West Station Lofts

Addendum #TTF-1

Date: July 18, 2017

Reference Drawing: TTF Drawings M-0 to M-9: Issued for Addendum #1 on July 17, 2017

Drawing M-1: HVAC layout – ground floor

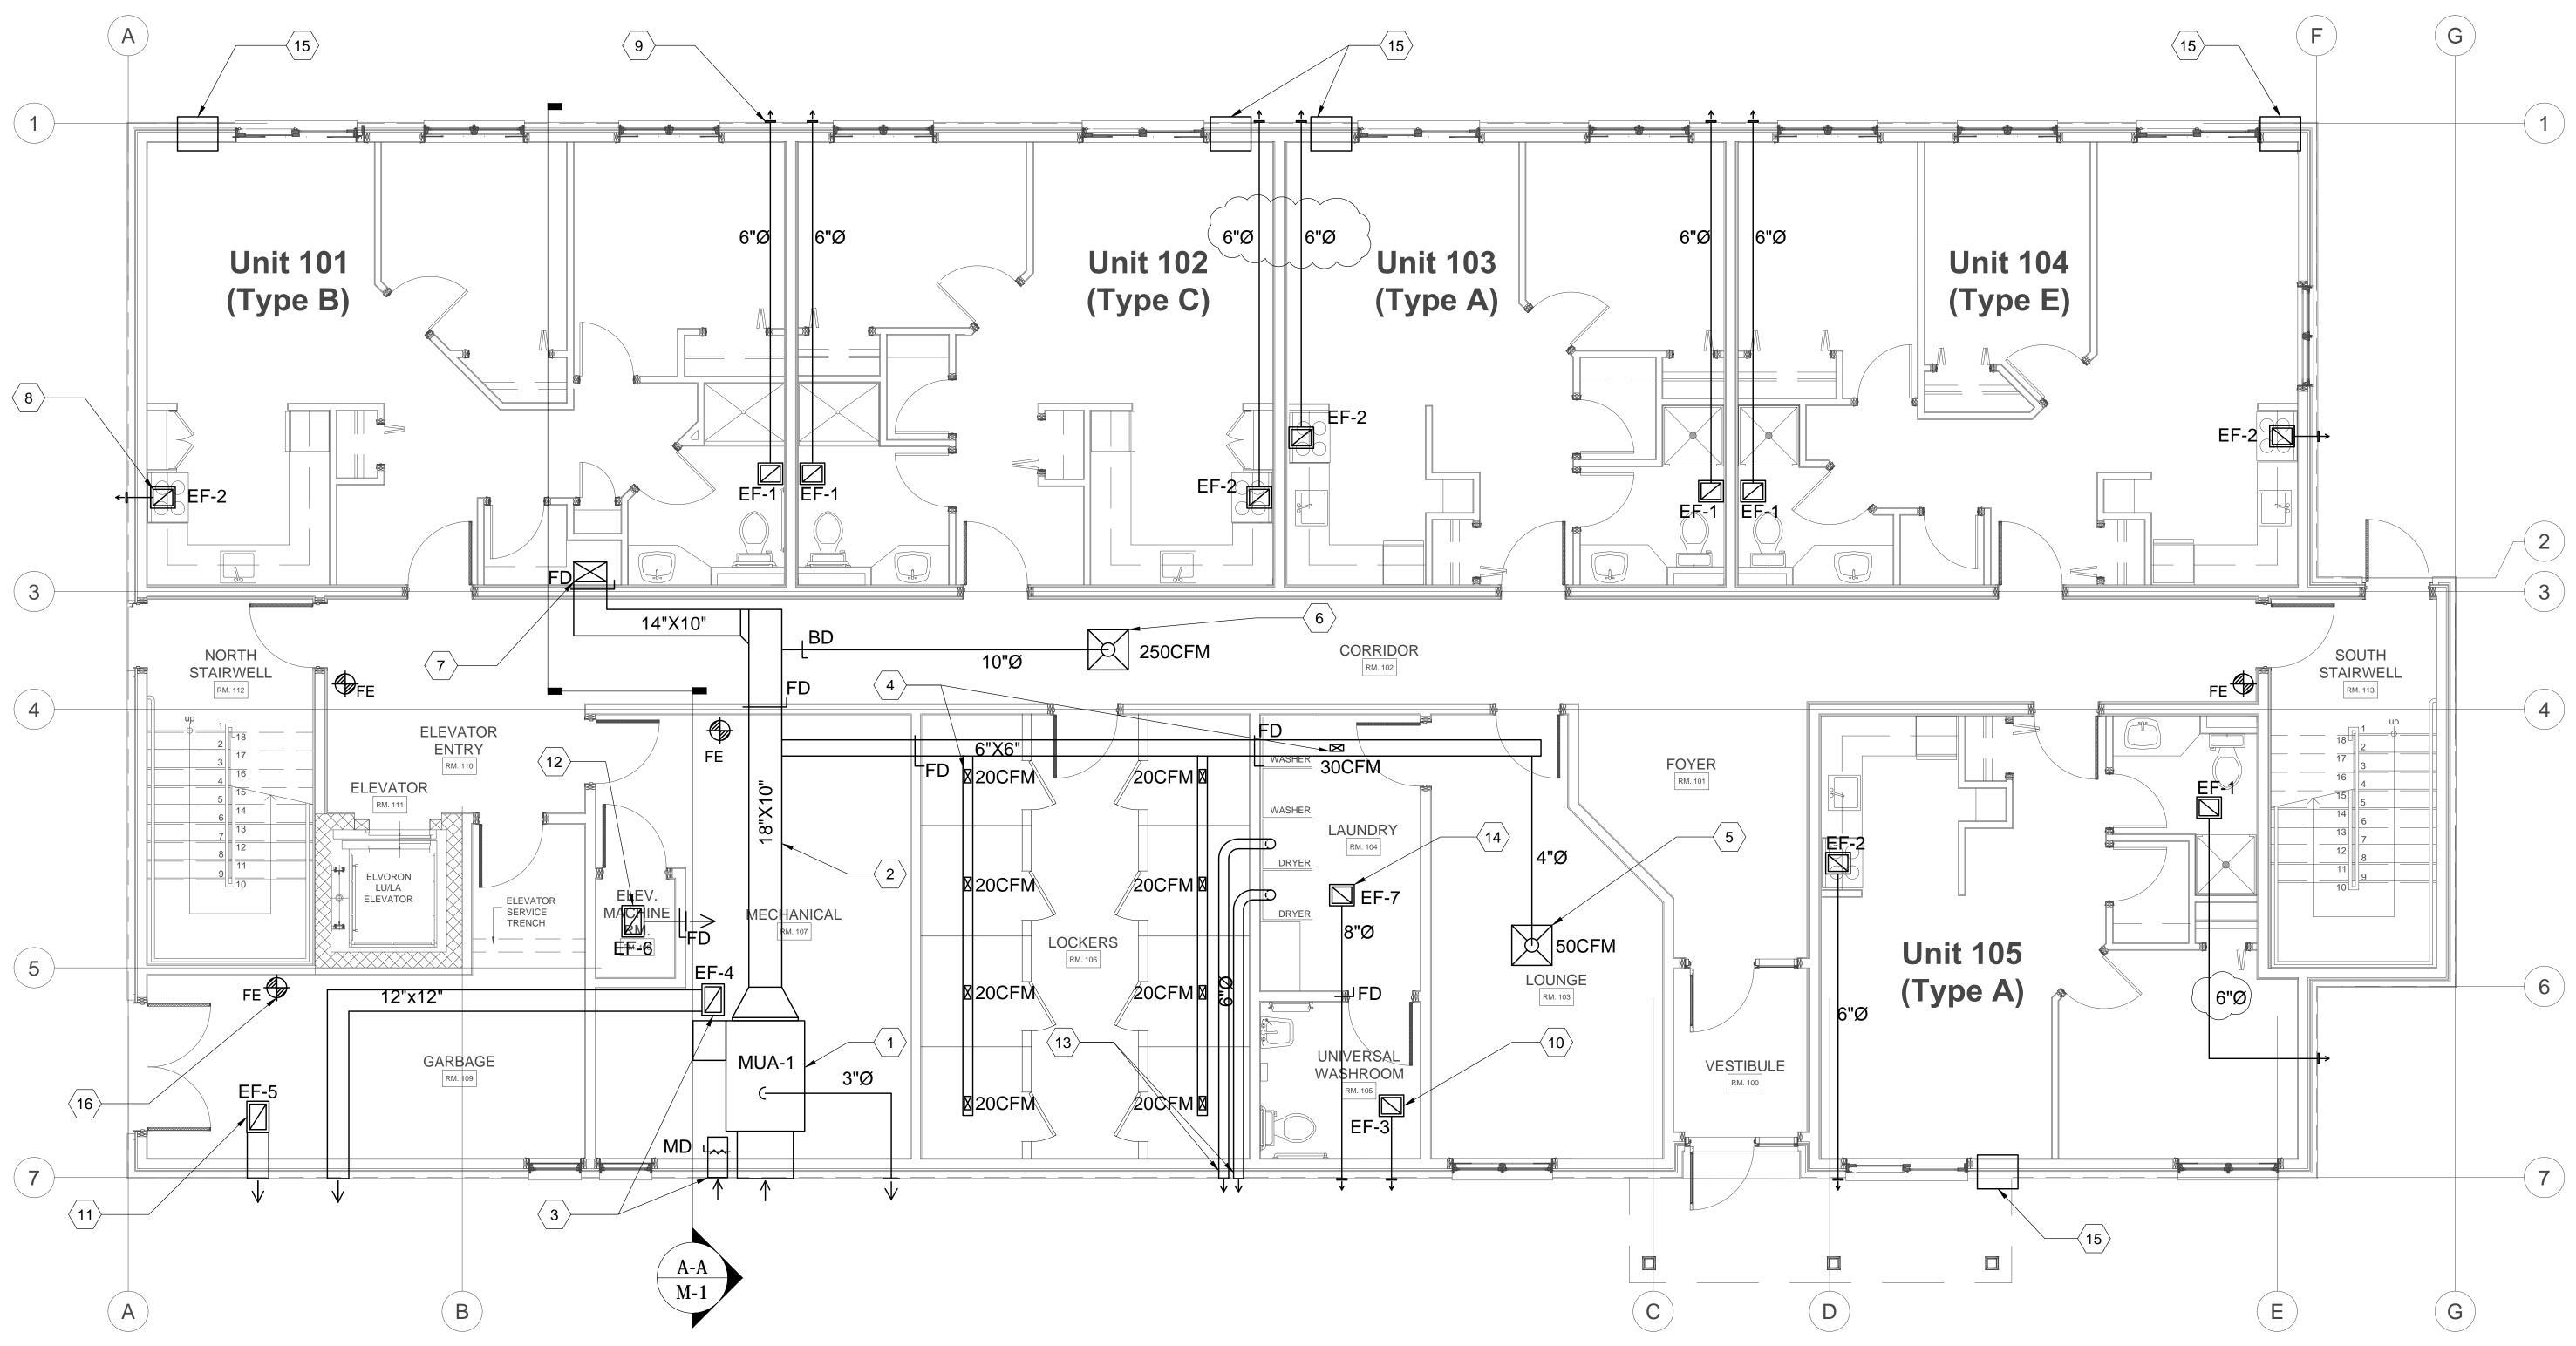
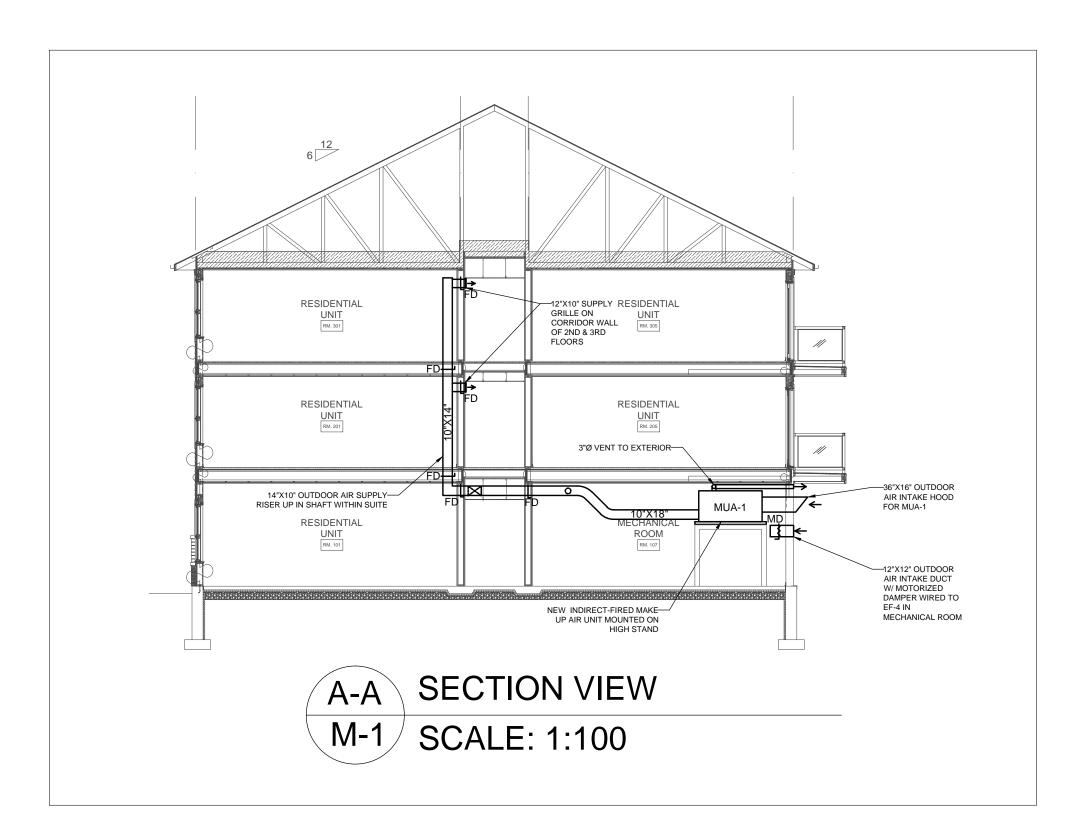
4. Some of the kitchen and bathroom exhaust ducts are shown routed across the middle of the room. I The preference is to run these ducts parallel to the division walls separating each tenant space and has indicated that on the building sections

Exhaust duct from kitchen exhaust fan EF-2 has been reduced to 6". Refer to drawing note #8.

TTF Answer: ducts are rerouted. Refer to attached drawings.

- , PROVIDE 250CFM KITCHEN EXHAUST HOOD EF-2 & EXHAUST TO EXTERIOR WALL VIA 6"Ø EXHAUST DUCT. 2/ TYPICAL OF 5 ON THIS FLOOR. PROVIDE TOOCFM CEILING MOUNTED CABINET WASHROOM EXHAUST FAN EF-1 & EXHAUST TO EXTERIOR EXHAUST (9) WALL BOX VIA 6"Ø EXHAUST DUCT. TYPICAL OF 5 ON THIS FLOOR. WIRE EXHAUST FAN TO LIGHT SWITCH IN

Drawing M-4: Domestic water layout – ground floor

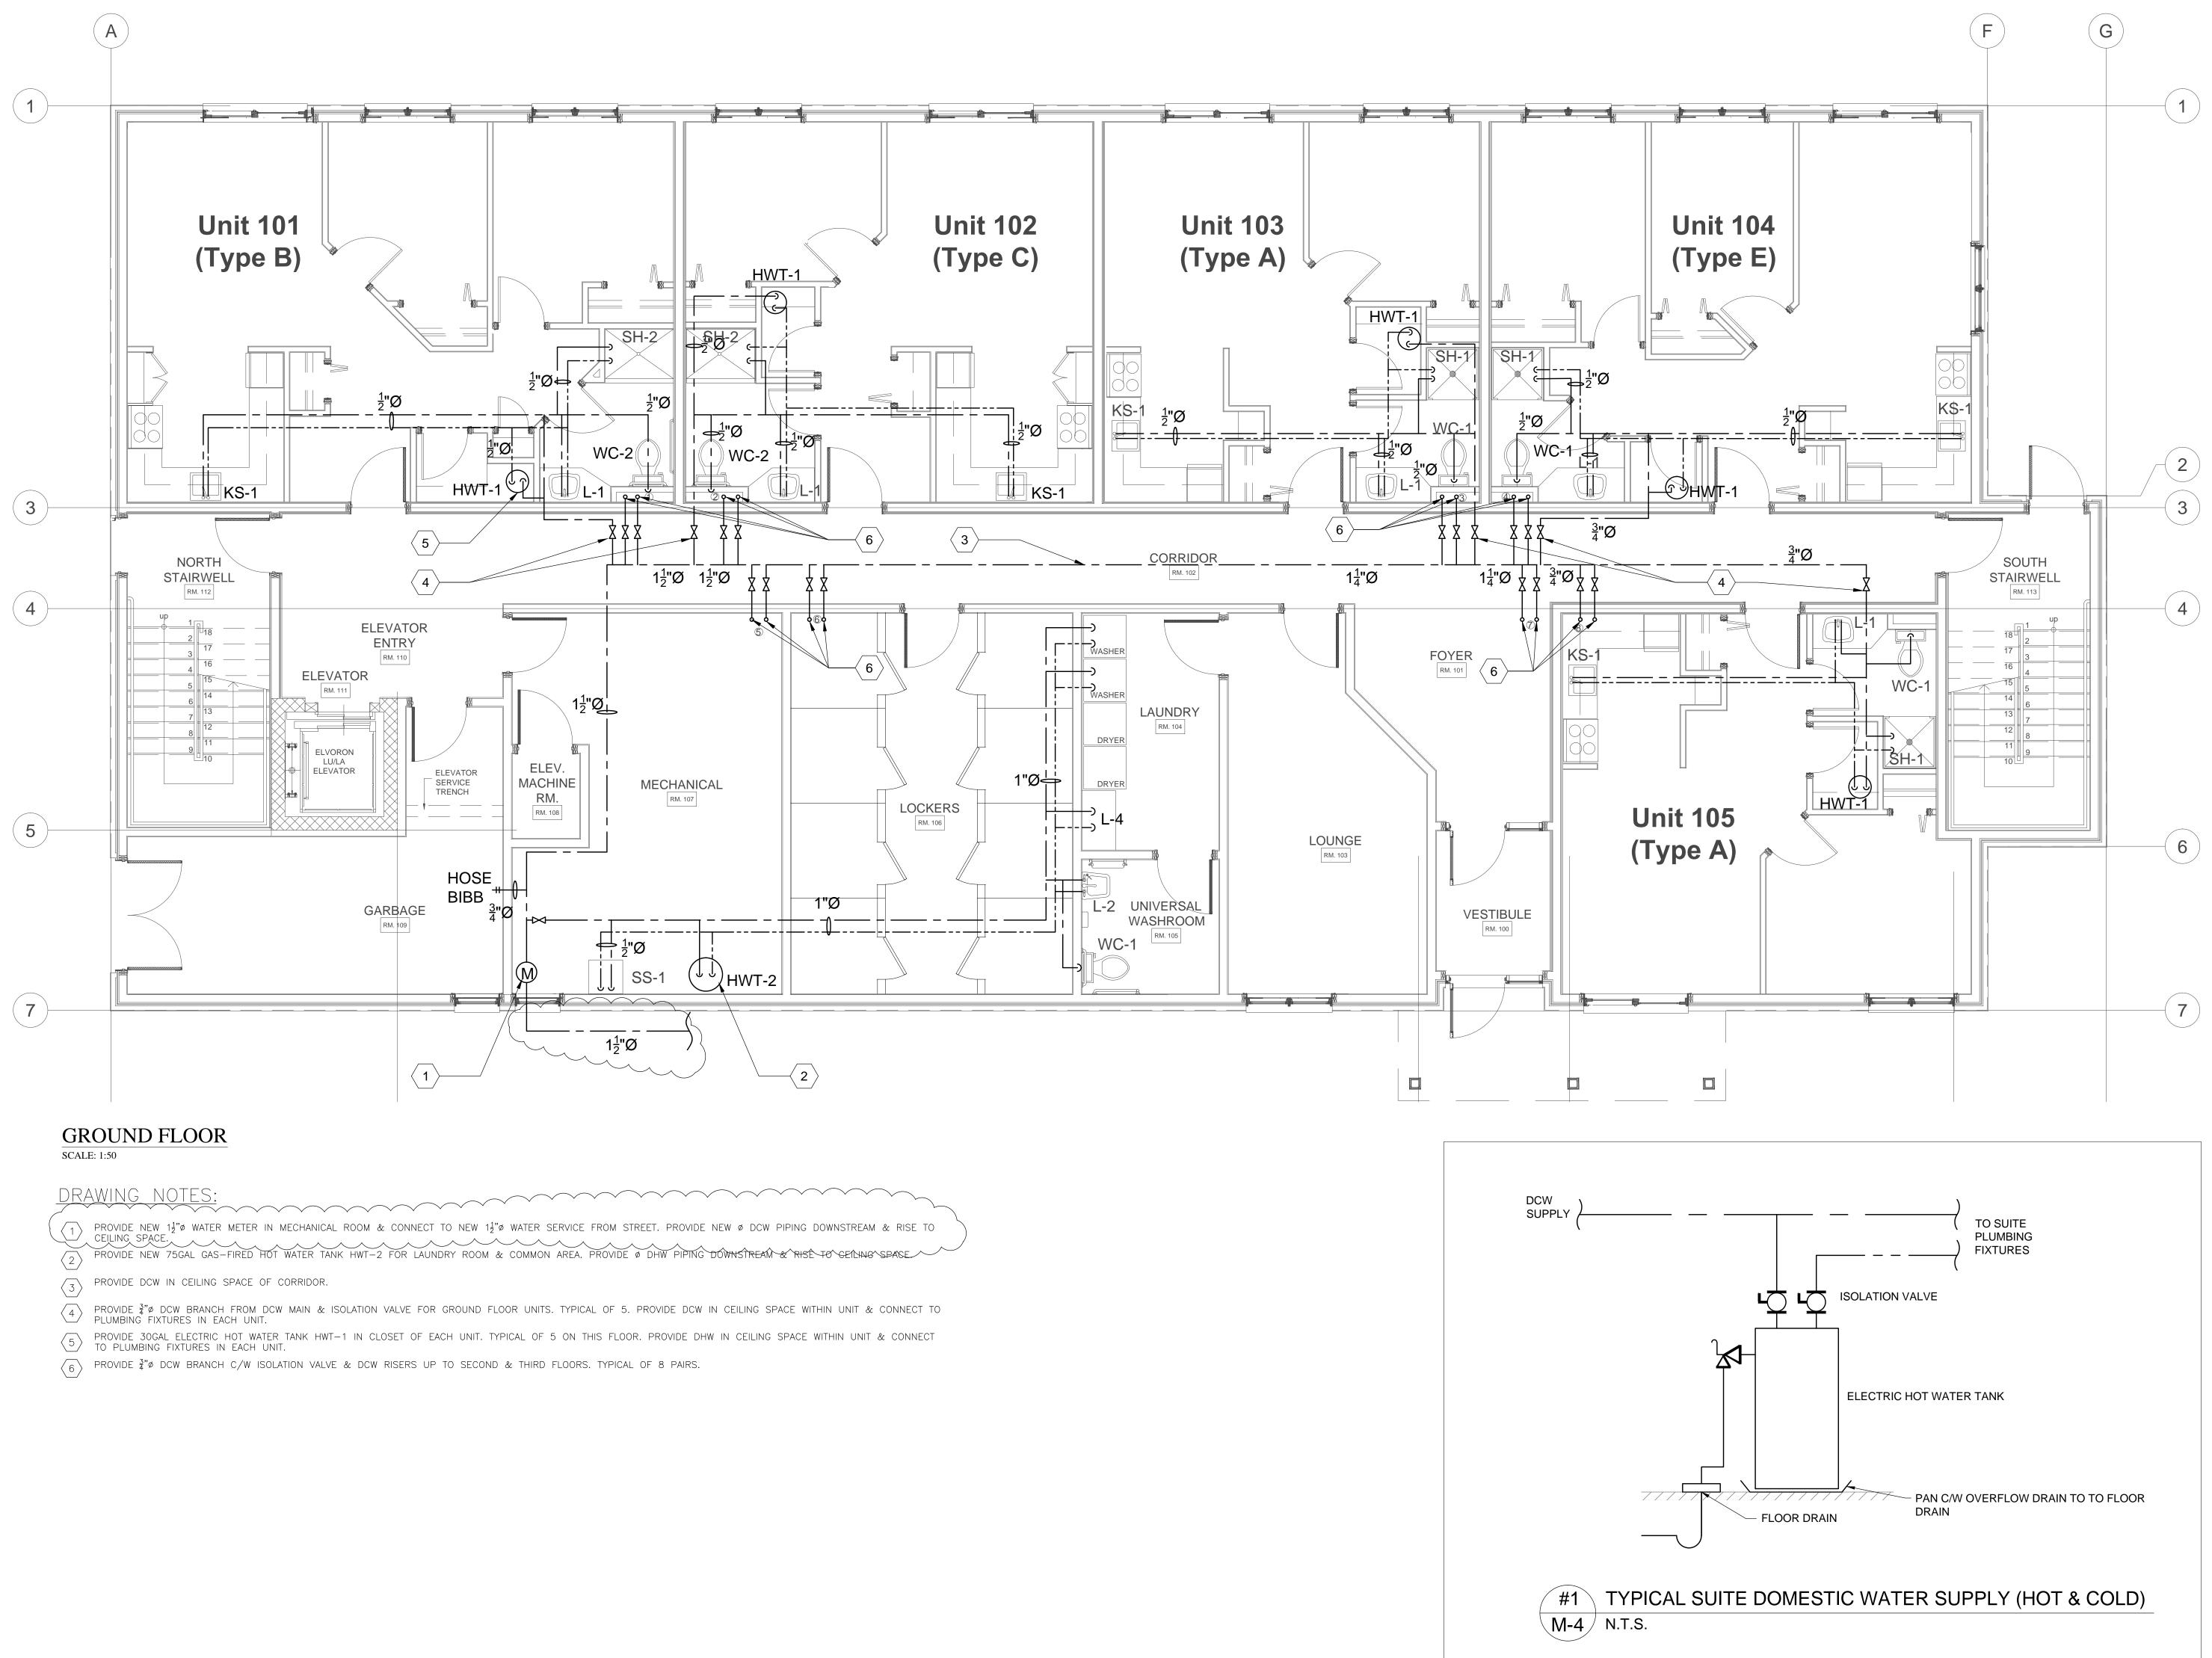
6. Please confirm the water service size. Is it possible to reduce to 1 ½" dia. service as noted on the civil drawings?

Item A1-5 Incoming water service size has been reduced to 1 ½". Refer to drawings note #1.

TTF Answer: Yes 1 1/2" service is adequate. Refer to attached drawings for updated pipe sizes.

Drawing M-7: Elevations

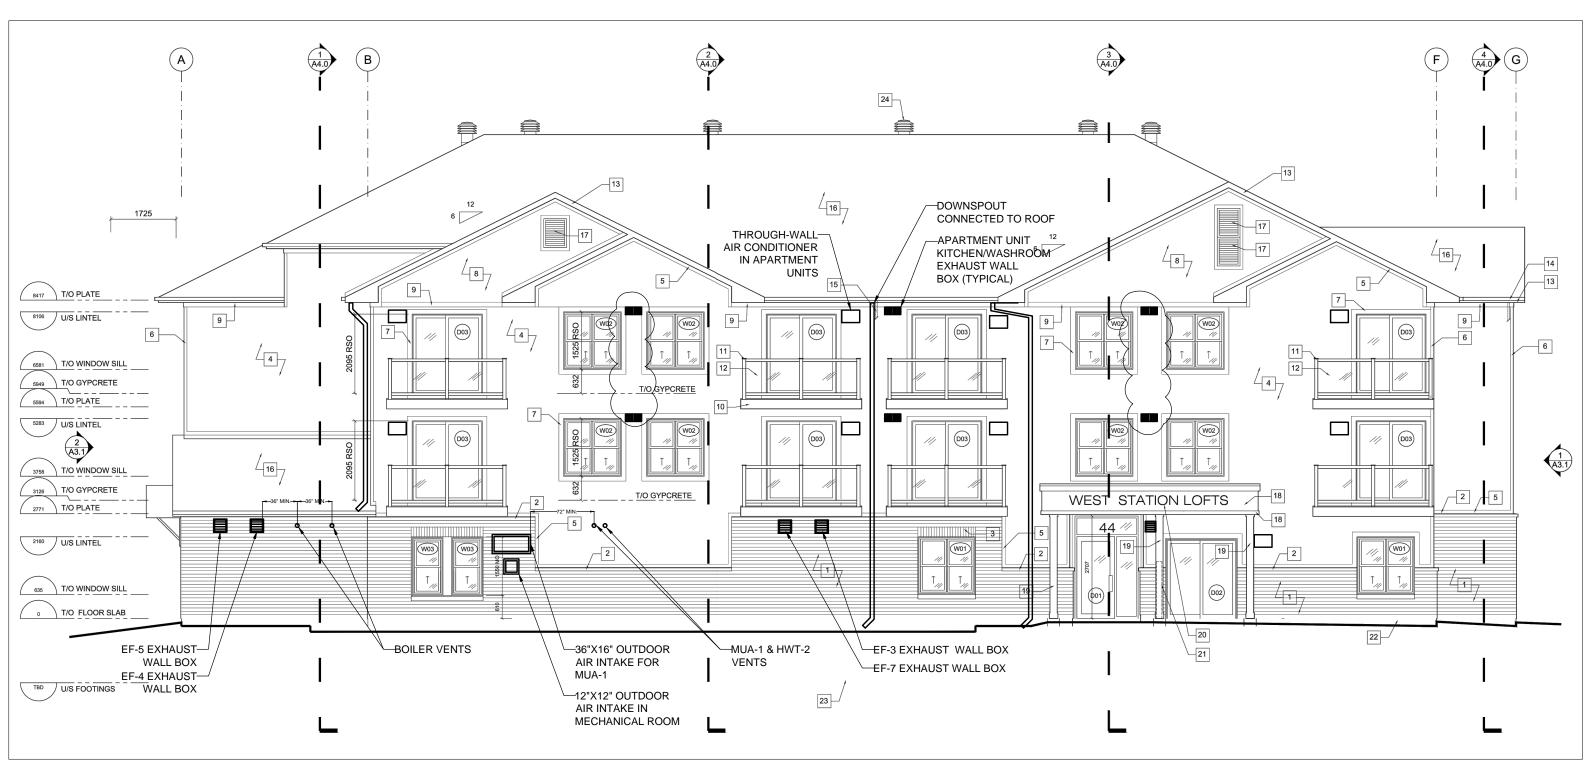
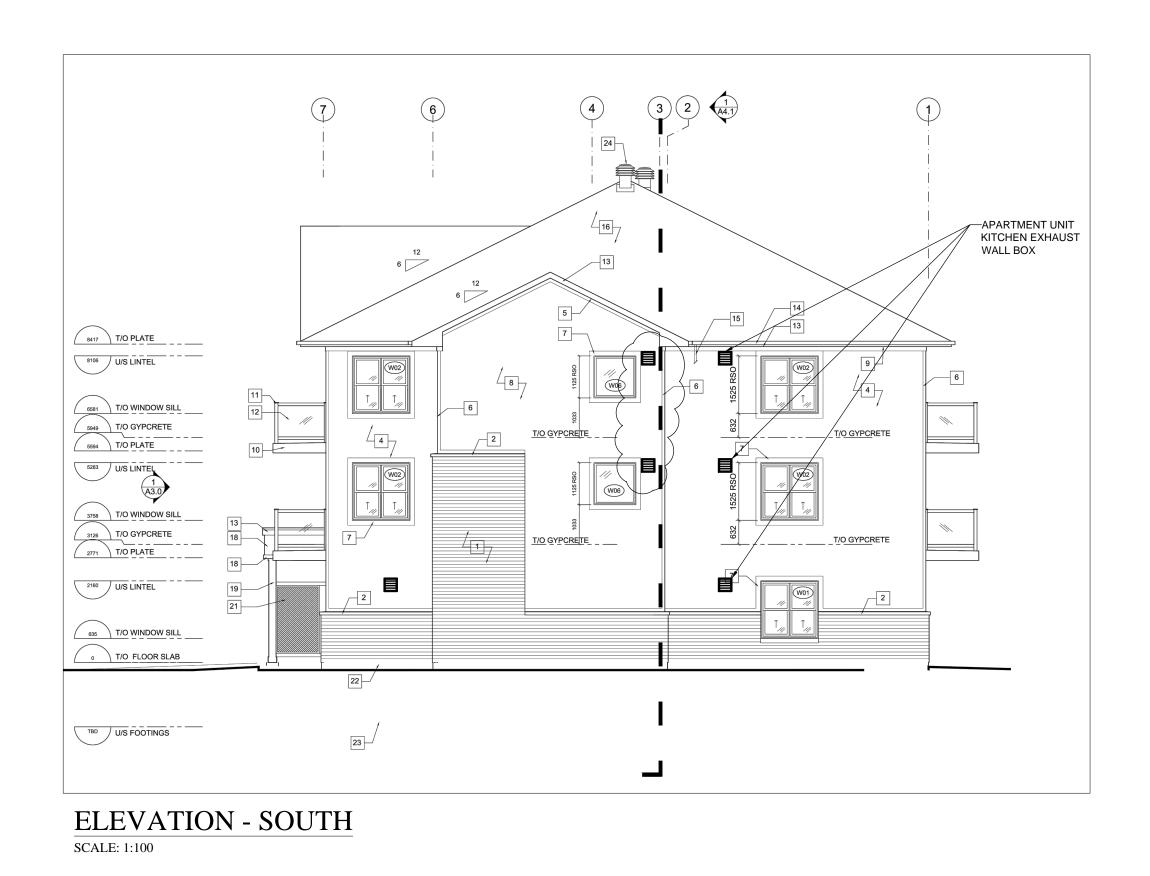
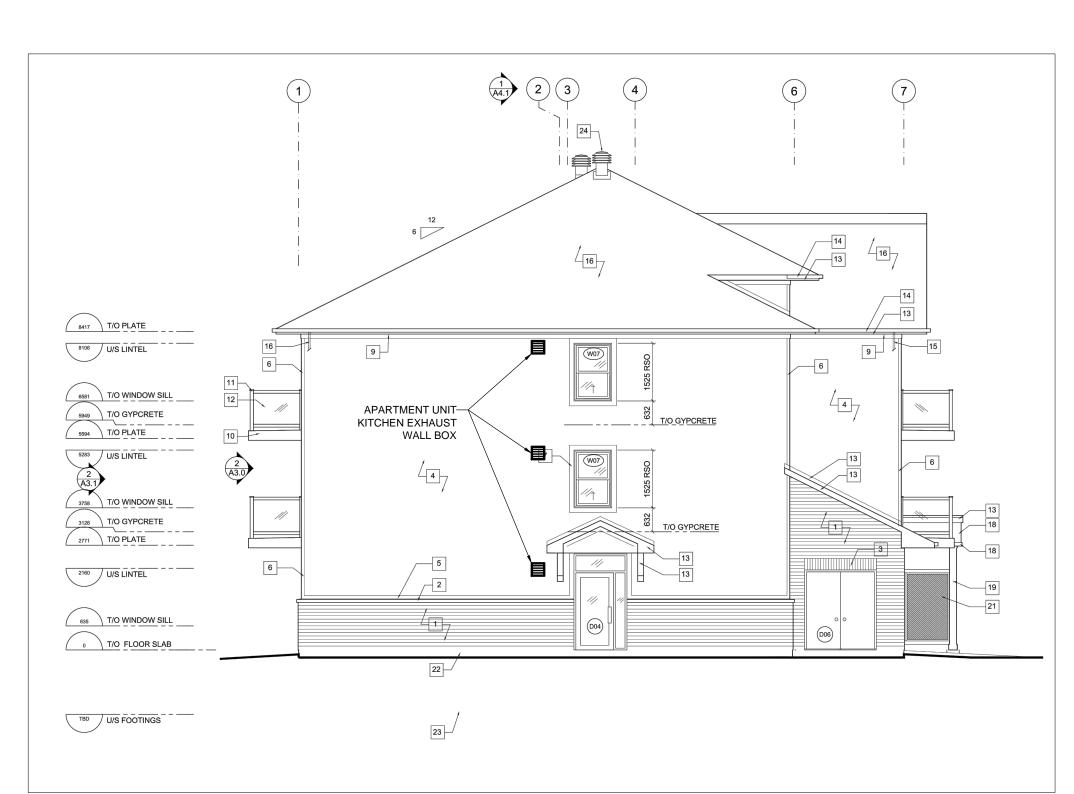
Item A1-6 Locations of exhaust wall boxes have been updated.
